**RESOLUTION NO. 2021- 99  
RADNOR TOWNSHIP**

**A RESOLUTION OF RADNOR TOWNSHIP, DELAWARE COUNTY,  
PENNSYLVANIA, APPROVING THE PRELIMINARY/FINAL LAND  
DEVELOPMENT PLAN FOR CG WAYNE, LLC FOR THE  
PROPERTY LOCATED AT EAGLE ROAD AND RADNOR ROAD**

**RE:** Eagle and Radnor Roads

**Reference:** CG Wayne, LLC - Eagle & Radnor Roads  
Radnor Township, Delaware County  
Transportation Review 6  
G&A #20-10023

PROPOSED 18 LOT  
 SITE PLAN

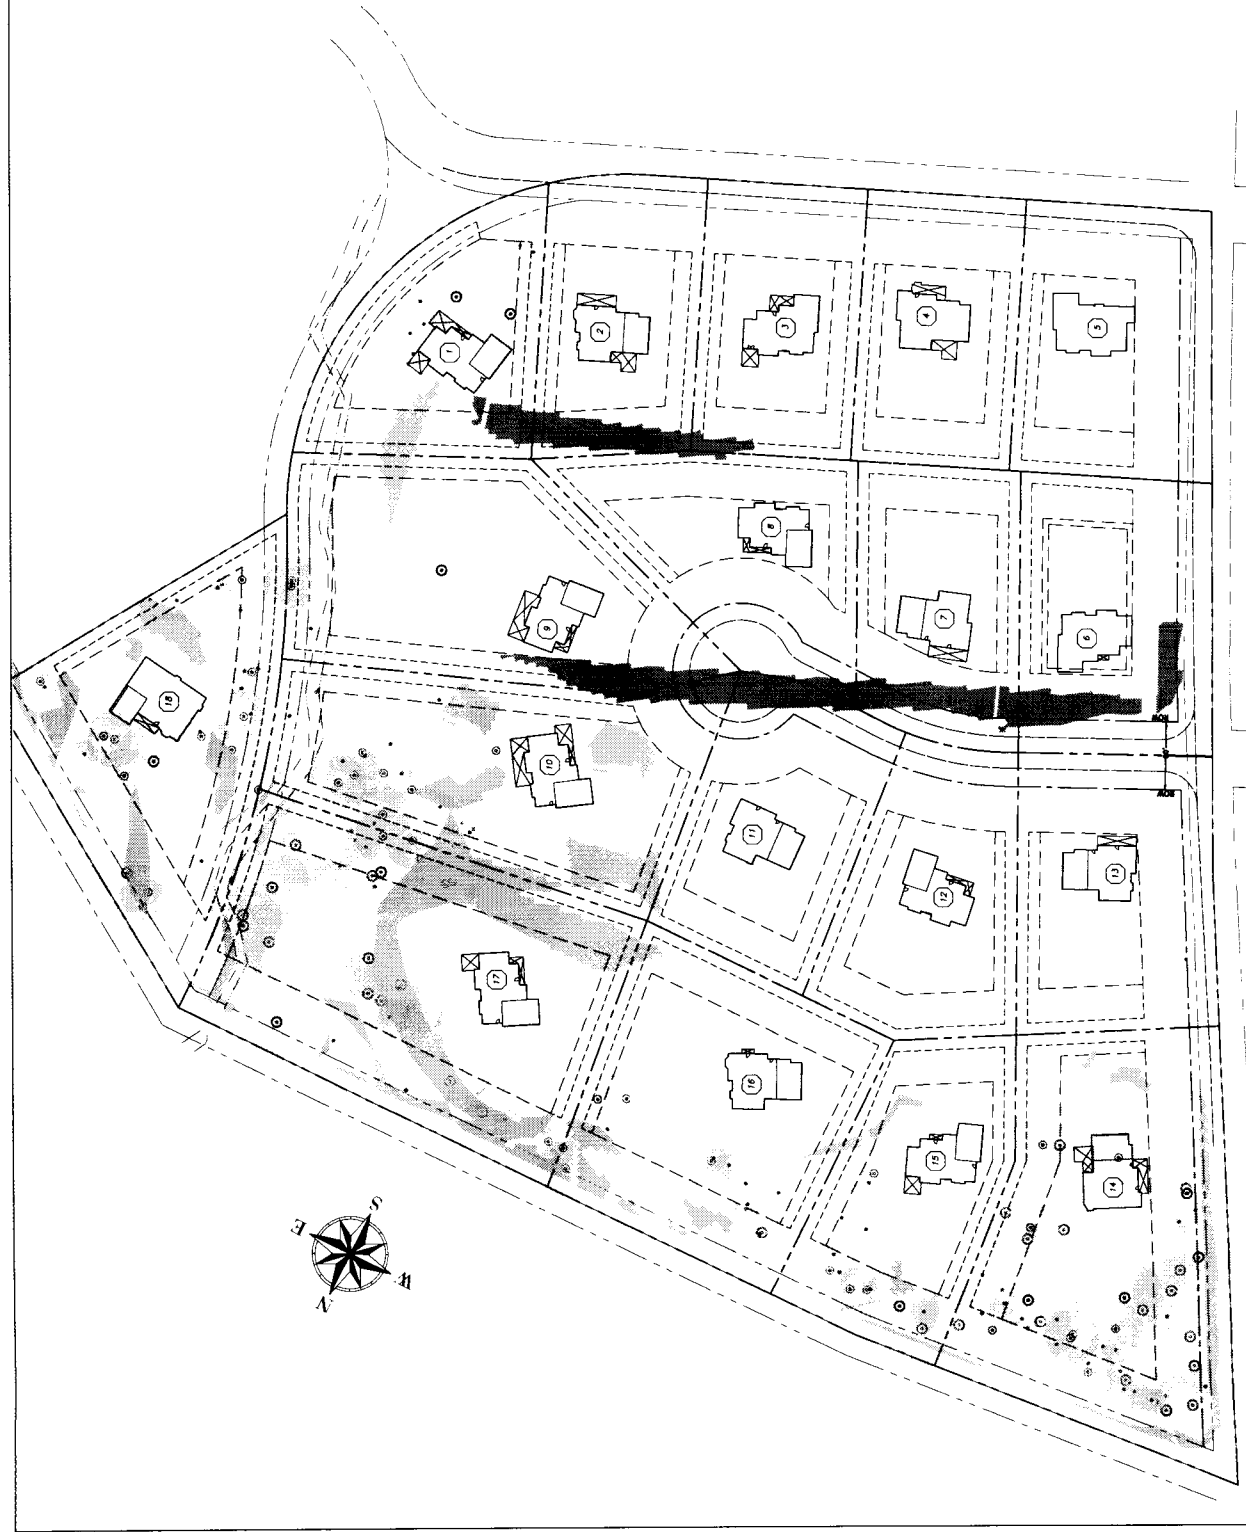
3. The Applicant agrees to modify or change the location of the dwellings located on lots 4 and 5 as depicted on Sheet 7 of 18 of the Preliminary/Final Land Development Plans. The Applicant further agrees that the location of dwellings located on lots 4 and 5 shall be moved back towards the rear of their respective lots to align with the location of the dwelling located on lot 3.
